## **Bayside Planning Panel**

Item No	<b>6.1</b>
Application Type	Section 96(2) Application – Modification to Residential Flat Building
Application Number	DA-13/56/03
Lodgement Date	24 November 2017
Property	<b>13A Church Avenue, Mascot</b> Lot 1 in DP 547700
Owner	A & S & S Mohebbaty
Applicant	A & S & S Mohebbaty
Proposal	Section 96(2) Application to modify Development Consent No. 13/56 to increase and alter the design of the building in respect of apartment size, car parking, and unit mix, to increase FSR and height, review Section 94 contribution and deletion of level 3 basement.
No. of Submissions	Six objections (Round 1) One objection (Round 2)
Cost of Development	N/A
Report by	Andrew Ison - Senior Development Assessment Planner

## Supplementary Planning Assessment Report

Figure 1. Amended Basement Level 1 plan

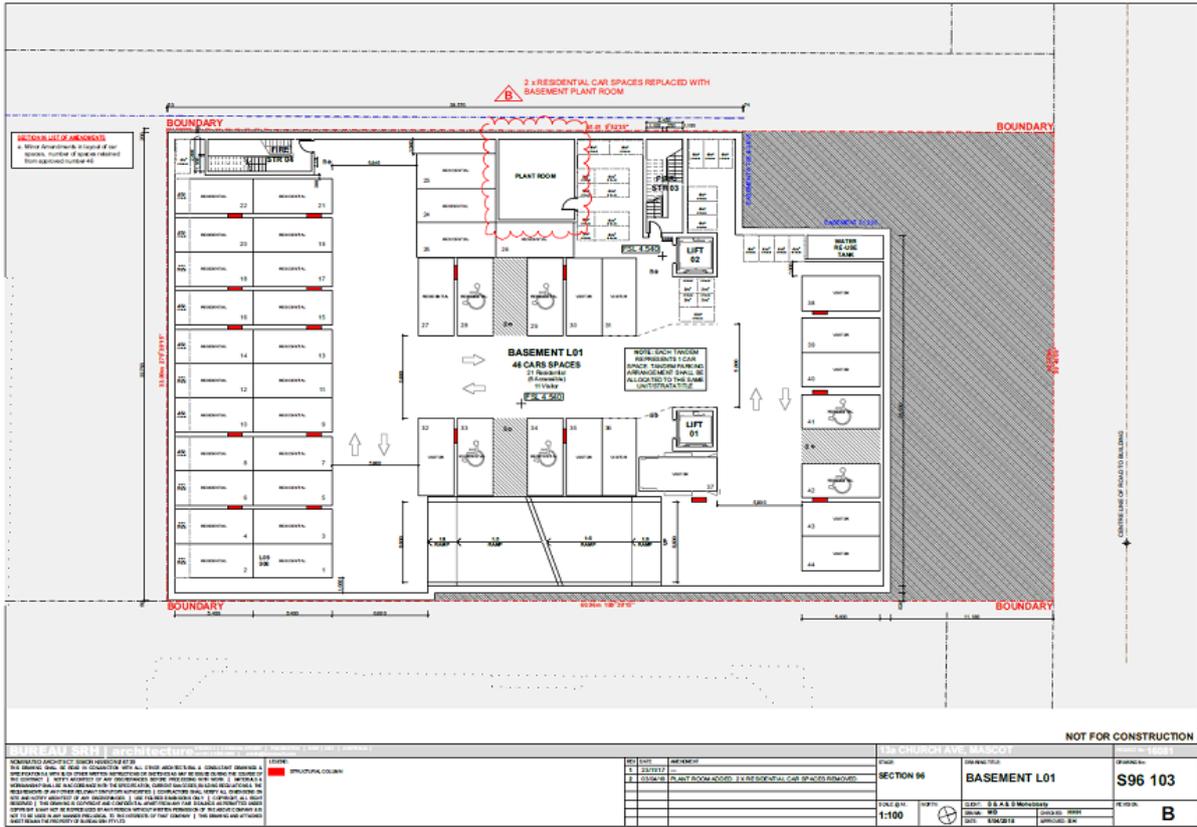
The layout of basement level 1 has been amended to delete two car parking spaces to accommodate space for the plant along the western edge. This has subsequently reduced the overall size of the rooftop plant area from a total of 115m<sup>2</sup> to 51m<sup>2</sup>, with the west plant deleted and the east plant reduce by 22m<sup>2</sup> from 73m<sup>2</sup> to 51m<sup>2</sup>. Subsequently the east plant room is now set back 3m from the southern and eastern facades.

With respect to the new plant room in the basement, the BPP report from 27 March stated that the proposed development had a surplus of 27 car parking spaces, hence from a numerical perspective the reduction is considered acceptable. The plant room location replaces two stacked parking spaces, both at the rear of the horizontal formation, and hence are deemed to not give rise to any concerns about compliance with the AS2890.1 requirements.

Figure 9. Amended West Elevation

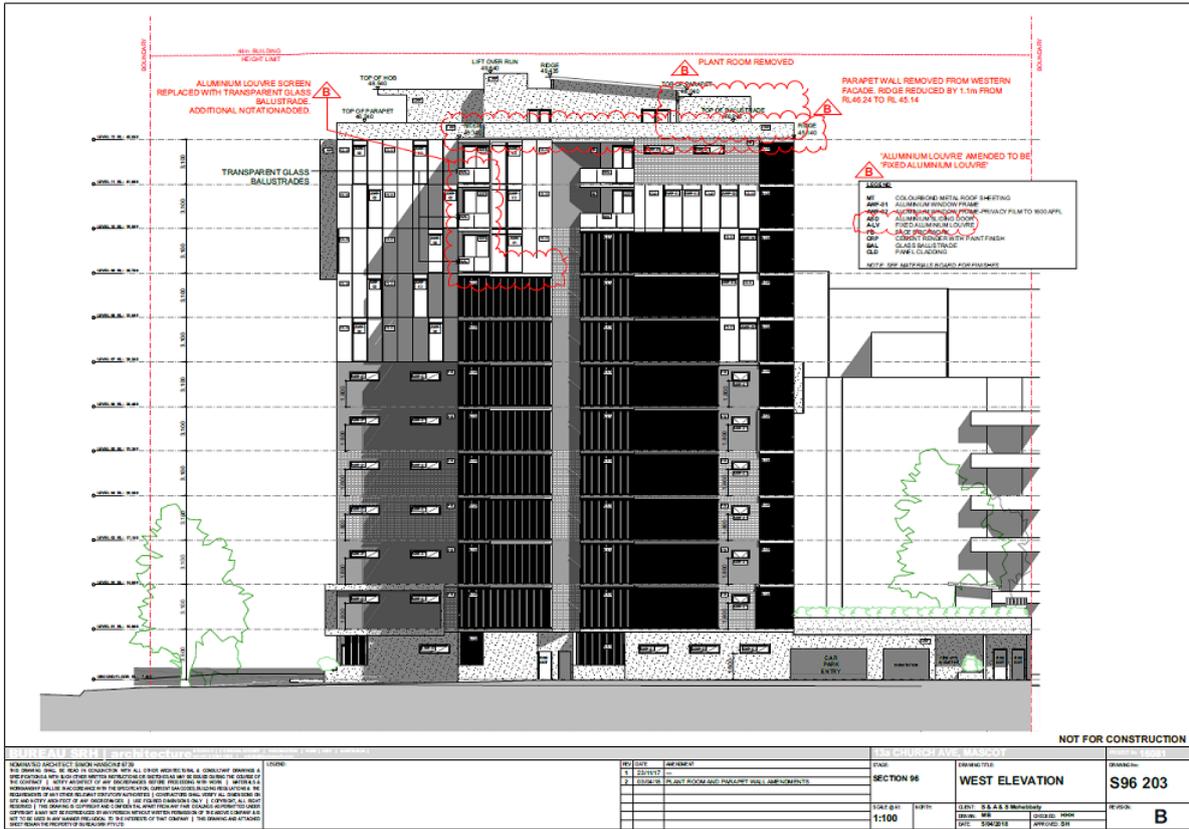
1.6 As shown on drawing S96 107 the parapet height on the western side has been reduced by 1.1 metres from RL 46.24 to RL 45.14.

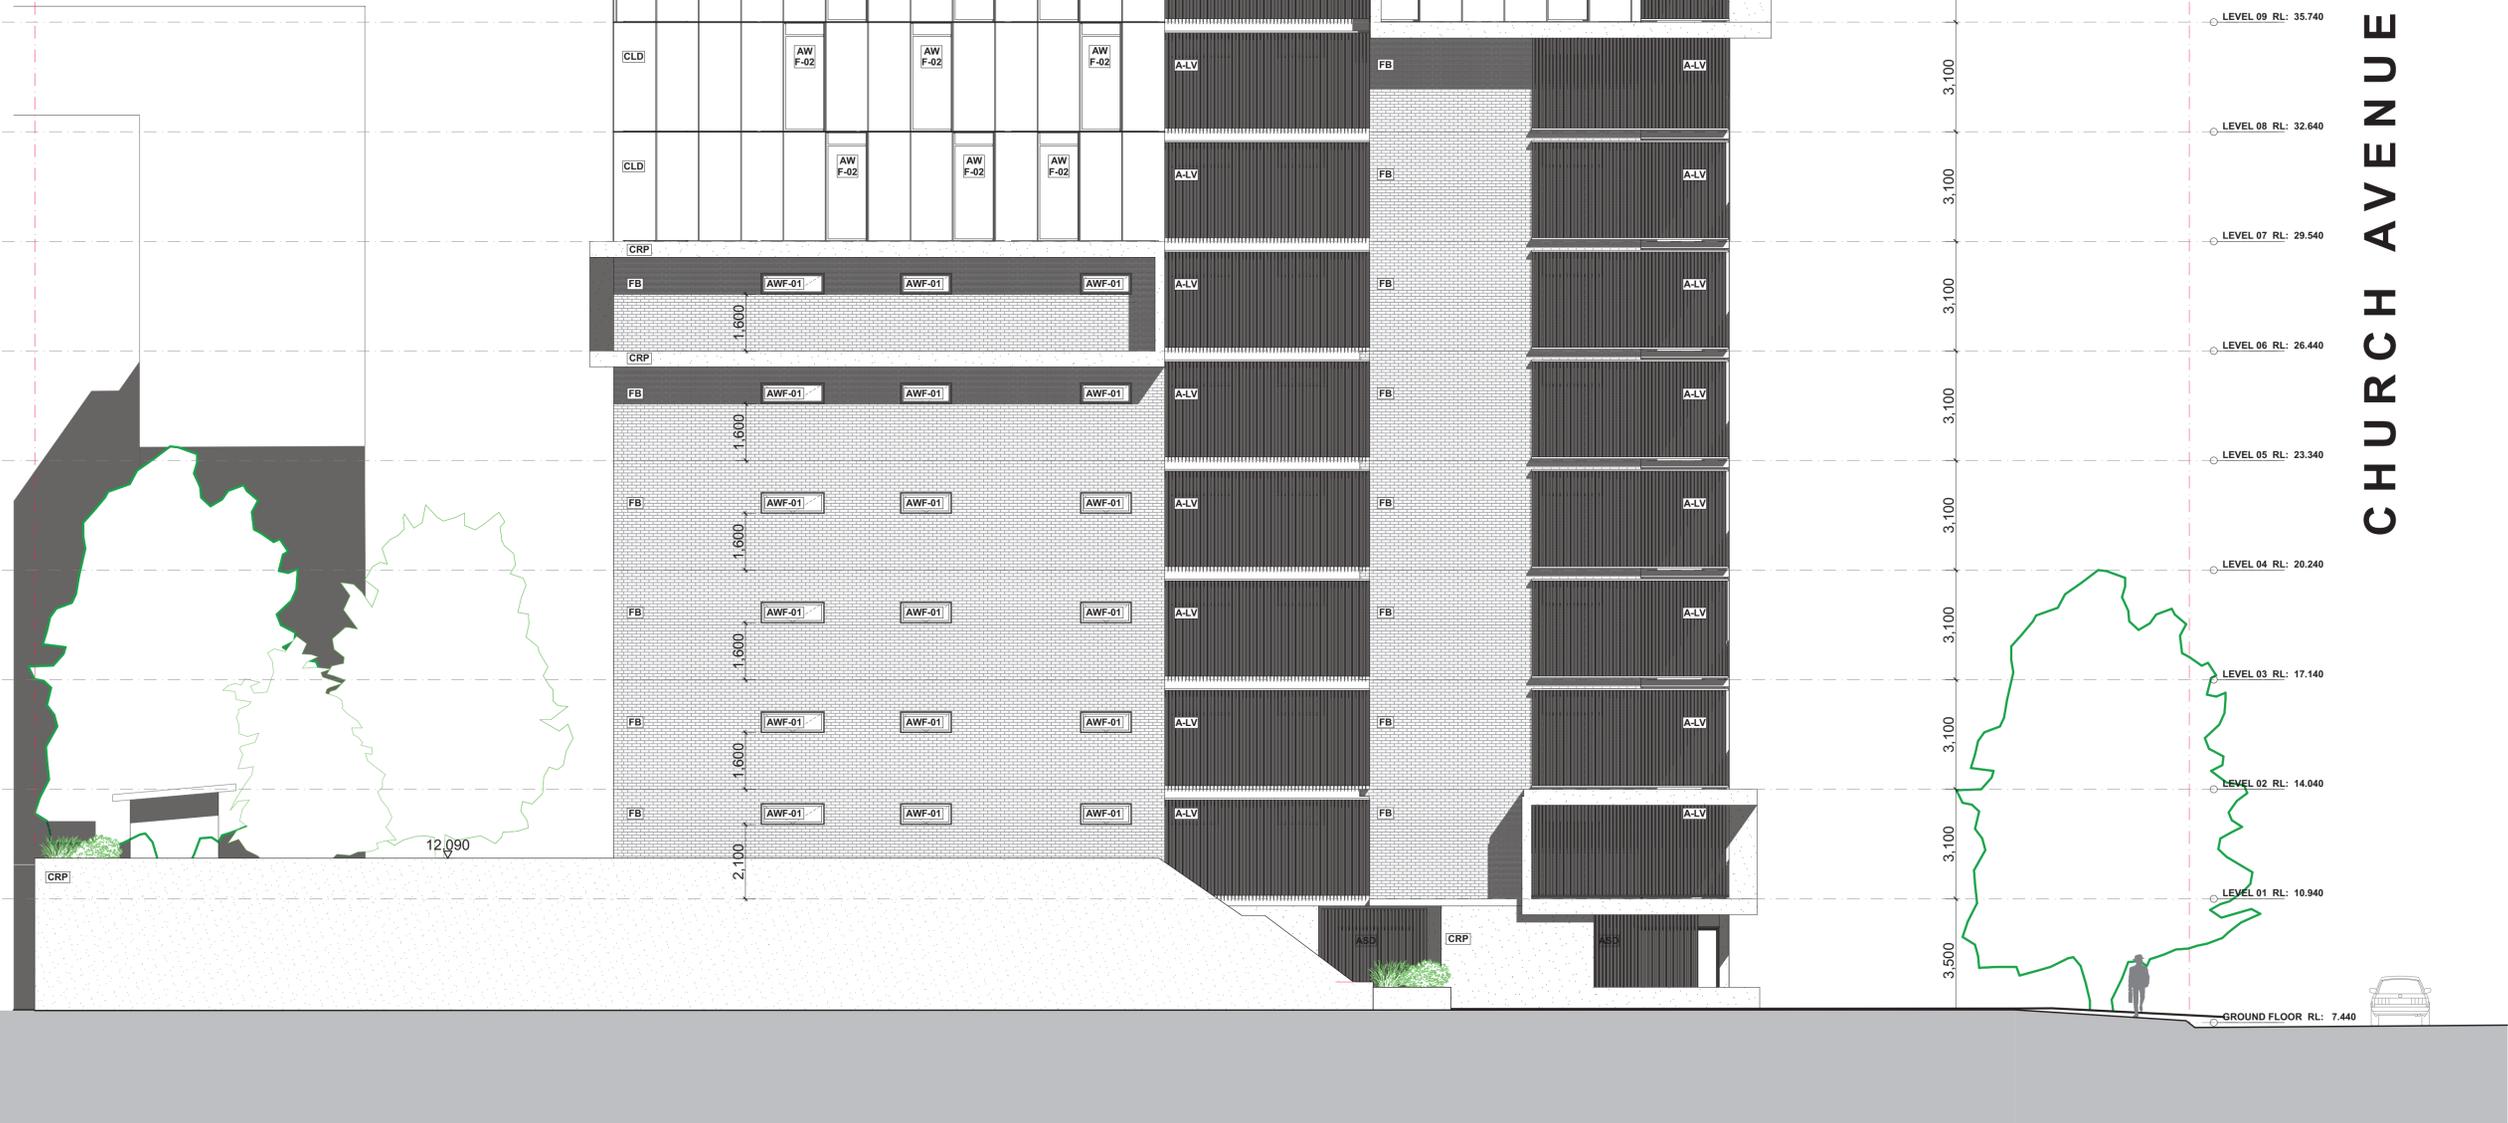
'ALUMINIUM LOUVRE' AMENDED TO BE 'FIXED ALUMINIUM LOUVRE'

**Figure 8. View Analysis submitted by the applicant**

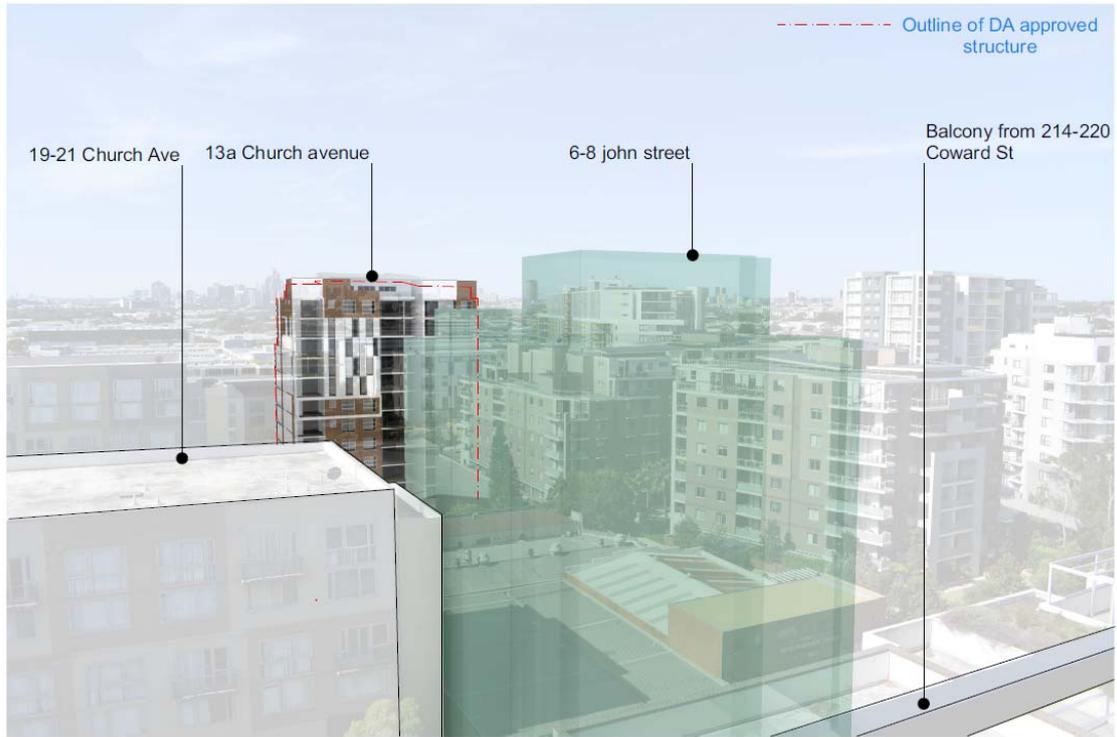
The view analysis provided by the applicant in Figure 7 is based on an angled view photograph taken from the objectors' property situated on level 11 at 214-220 Coward Street while standing on the edge of the balcony adjoining to the main living room. The view analysis does not clearly identify the differences between the approved and proposed development as the analysis is provided on an angled perspective. The proposed additional height of 2.7 metres that is almost equivalent to an entire new level has not been demonstrated on the view analysis. The bulk and scale of the entire building and not just the roof top/level 13 are actually increased. While the modification to height is lower than the maximum applicable height for the site as stipulated within the BBLEP 2013, the main bulk of the building has been raised by 1.1 metres, refer to Figure 9 above.

**Figure 8. Photographs taken by the Assessing Officer standing from the middle of level 11 balcony of 214-220 Coward Street adjoining to the main living room**

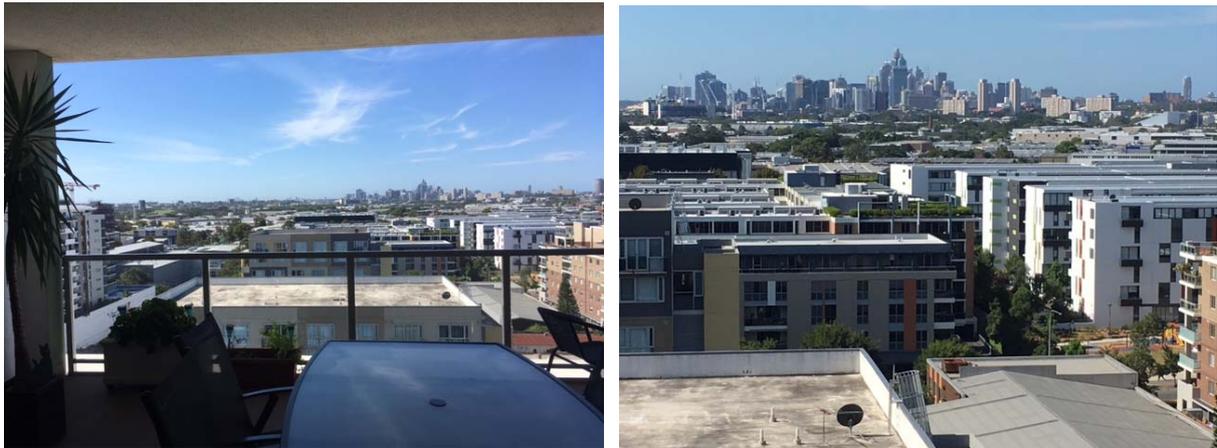
Council's Assessing officer has also visited the site to understand the view and carry out the view loss assessment. The photographs taken from by the assessing officer in Figure 8 from standing in the middle of the balcony adjoining to the main living room.

**Figure 10. Shadow Diagrams Winter Solstice 9am (L), 12pm (Middle) & 3pm (R)**

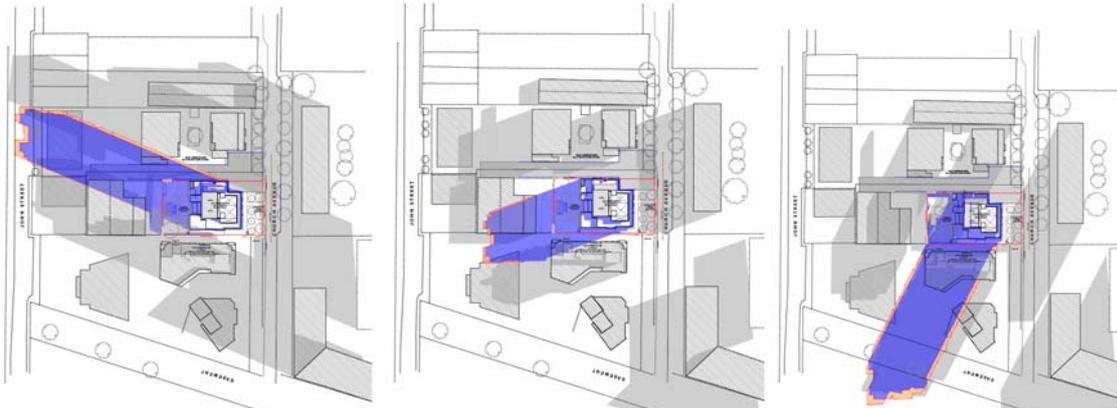
Due to the additional bulk and scale proposed, additional overshadowing will result from the development. However, due to the orientation of the site and approved height of the building, the additional shadow will be mainly cast on the adjoining streets, refer to Figure 10 below.
